Comments from 4/12 - Draft Responses

The following document covers the proposed path forward and responds to questions and comments from the April 12, 2017, Stakeholder Meeting. Please review this document prior to the June 21, 2017, Stakeholder Meeting. Questions regarding any topics on this list that you feel need to be addressed further are welcomed. Also, please provide ideas on how you would like to see them better addressed.

LISTING_31

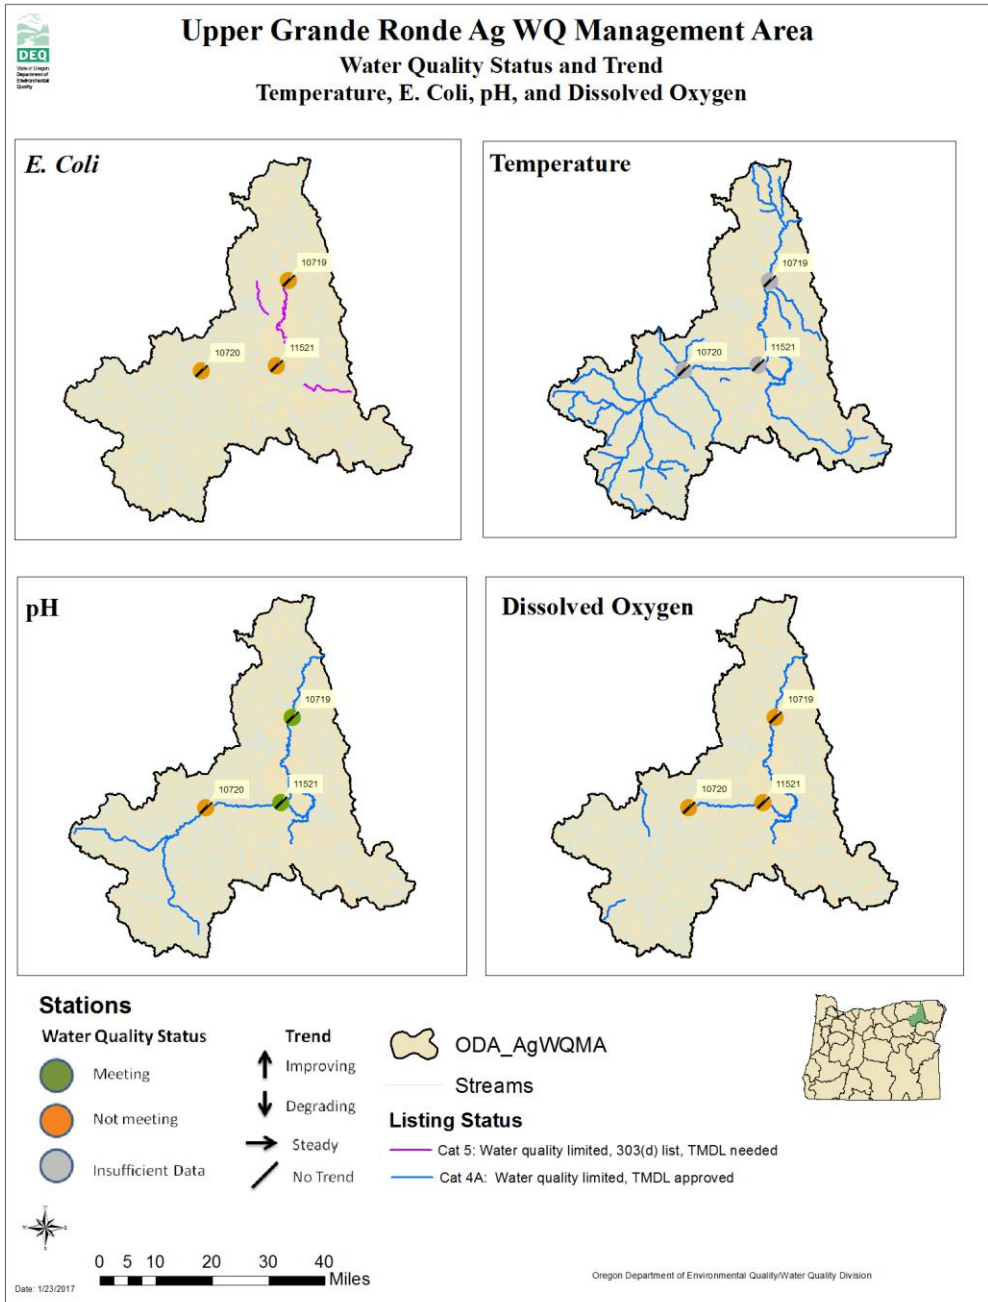
- **Comment: Provide 303(d) water quality information on a map**

Response: The following maps show water quality information. The map below shows waterbodies listed for any parameter, any time of the year.

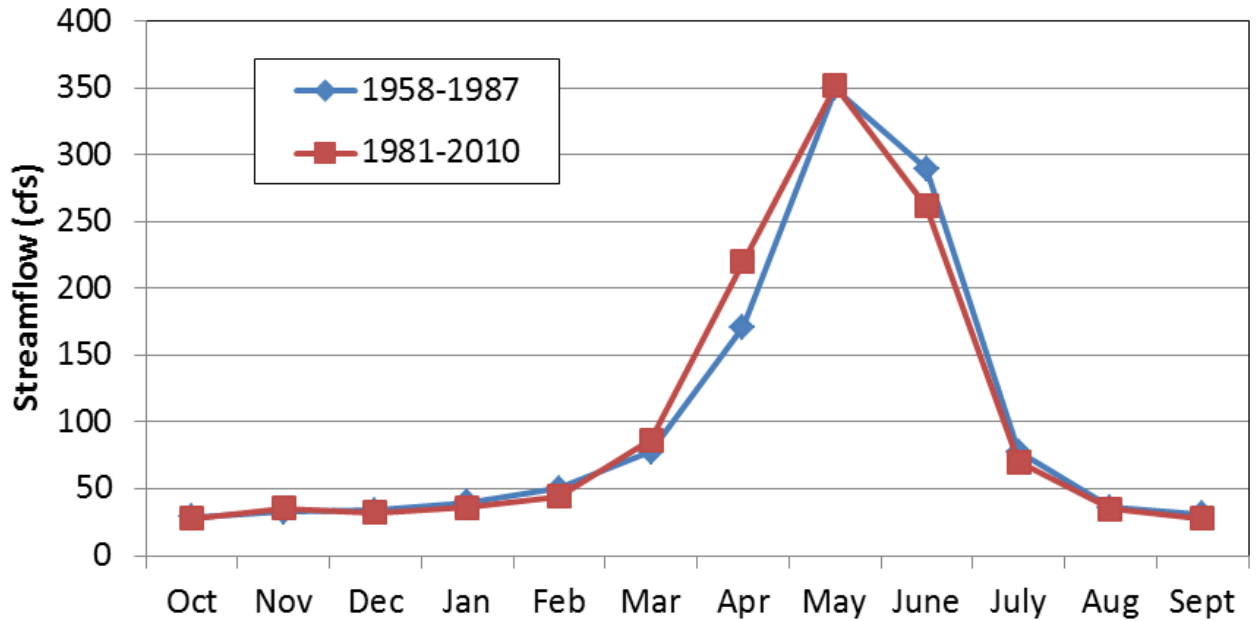
- ***Comment: Most of the beneficial use data criteria seems focused on fish (what are standards for other listed uses such as boating?) Maybe only include the uses for which there are criteria. Flow should potentially be removed from the chart. Chart seems limited.***

Response: See revised chart below. The charts focus on the most restrictive criteria for beneficial use, which is aquatic life use. The charts show other uses when the information is available. The report will describe what flow is as related to water quality in the general ecology/physical characteristics section of the report. Flow shown in the beneficial use table is only as applies to fish passage barriers (not water volume).

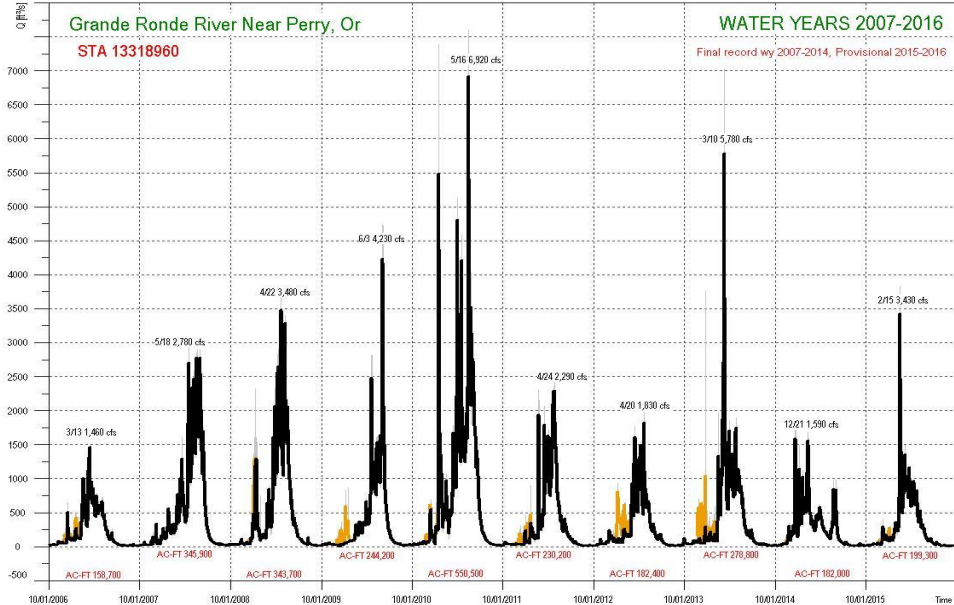
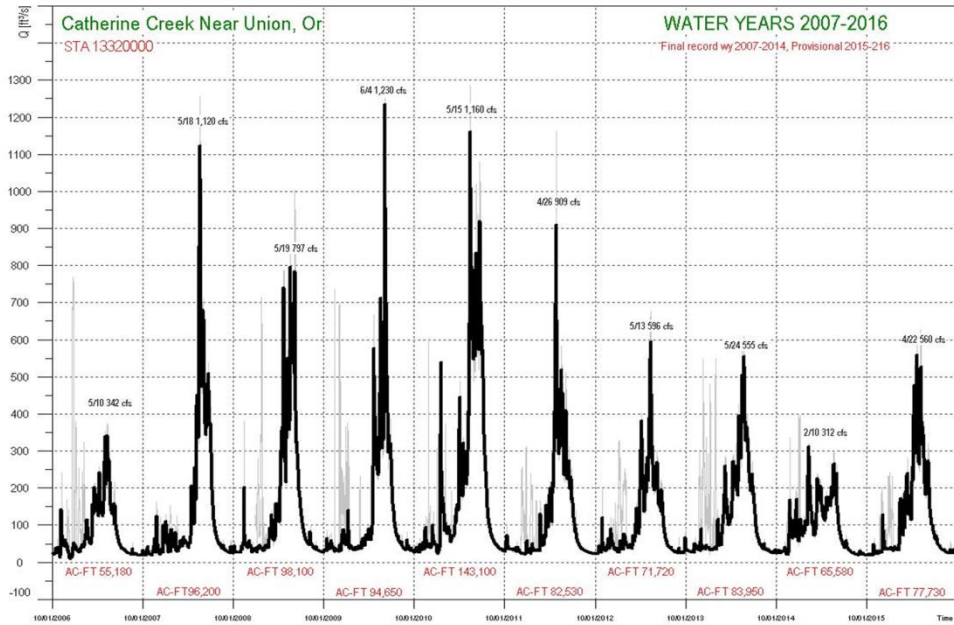
- Comment:** *Consider just showing gauged data (without consumptive use added in).*
Response: The following are two graphs of gauged data for Catherine Creek and UGR. We have data similar to this from a few other gauges in the basin. We are not planning to show this information in the report, because it does not serve our ultimate purpose to complete the water balance.

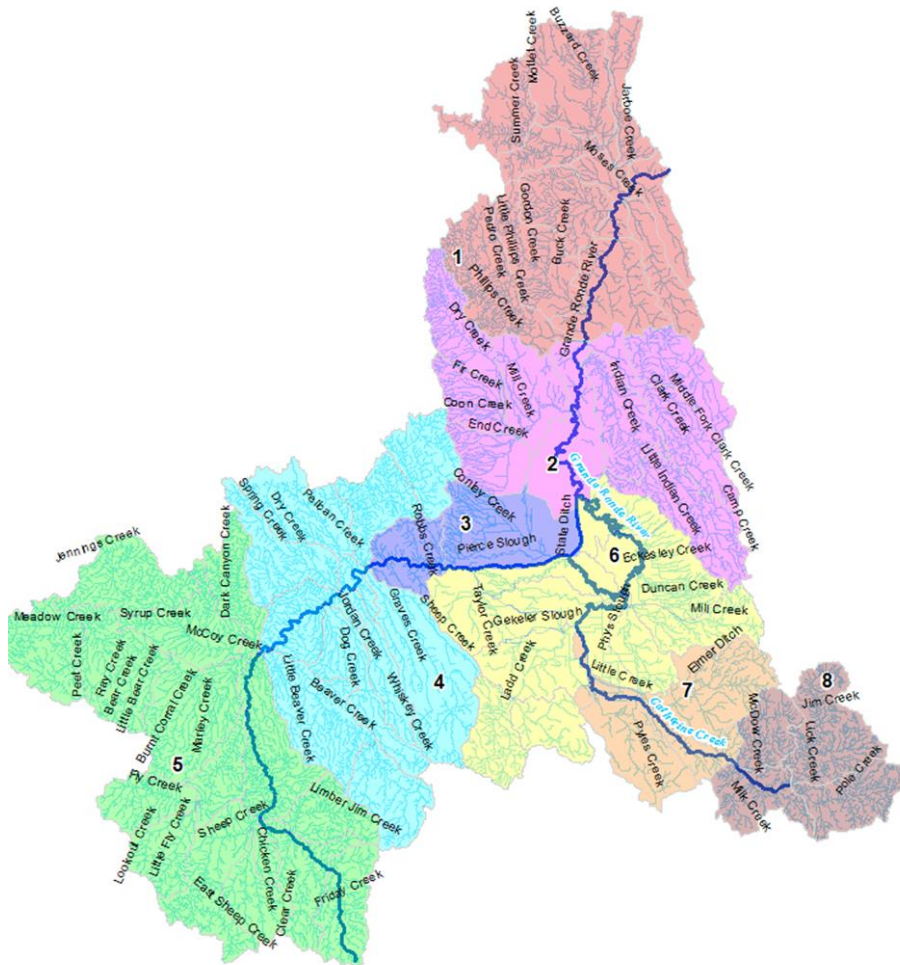
- **Comment:** The old river channel is shown on the map. We need to label it as the old channel to avoid confusion. Include more land marks on the large map and label tributaries.
- **Response:** Map is being revised. Review base map below (in addition one part will be marked at “historic channel”):

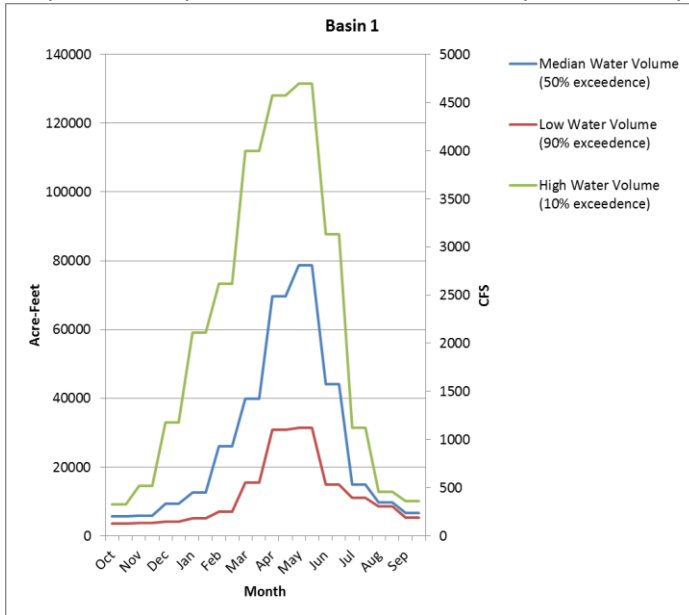
- Comment:** *Ac-ft vs cfs need to explain how information is shown on the chart.*
 Response: Graphs will be refined for the report. Ac-ft is per 2 weeks on this graph.

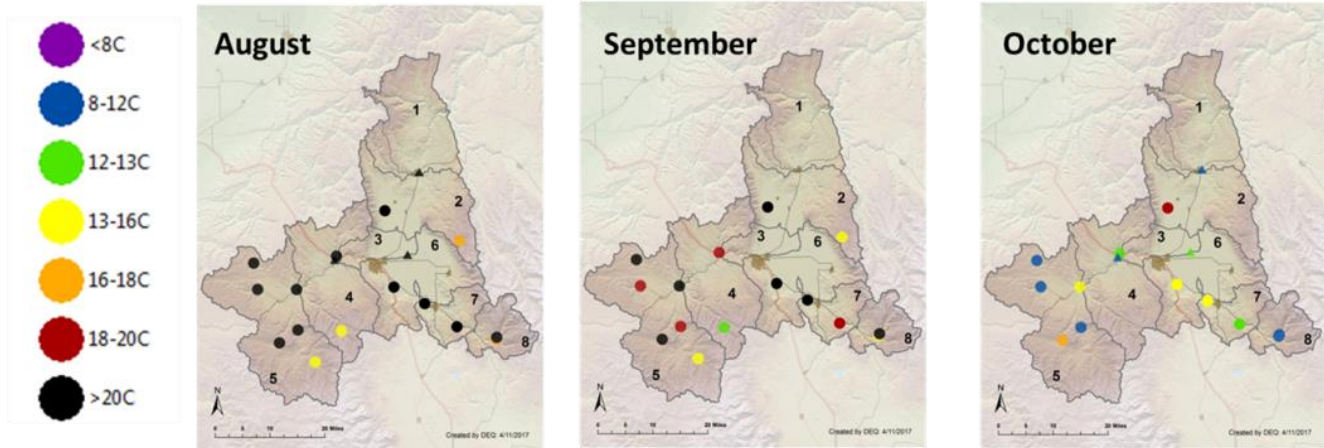
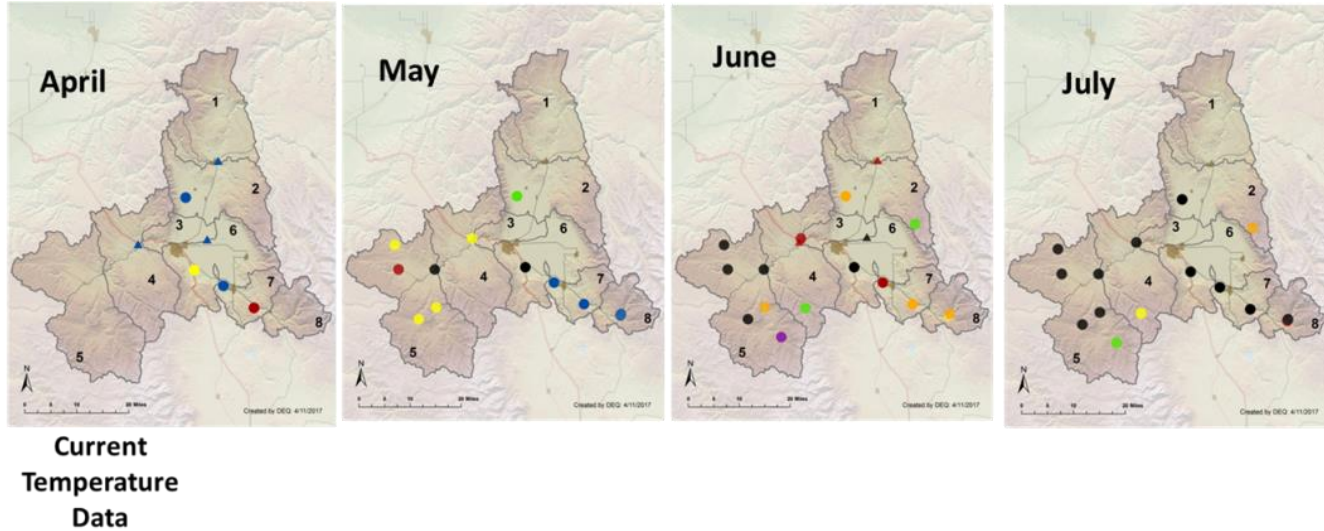
- **Comment: Temperature trends in bottom chart need to be explained**

Response: Unit measurements will be included in the report. Trends are that June to September most locations are temperature limited. October through May most locations are not temperature limited.

Monthly Climate Normals (1981–2010) – LA GRANDE, OR

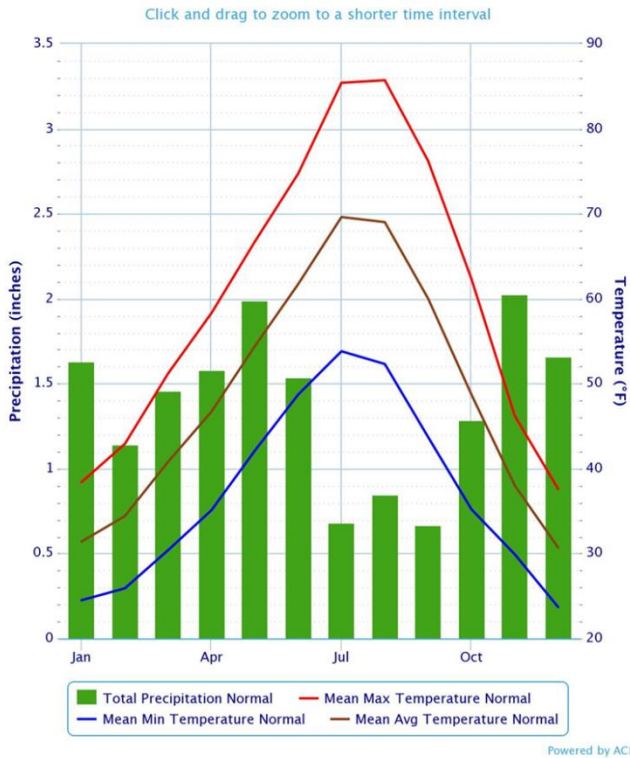
Approximate temperature pattern – again this is an approximation at this stage of the analysis and would contain mean monthly air temperature values.

This is the level of detail that we plan to present in the report. 8 subbasin level data for air temperature is more detailed than the actual data we have.
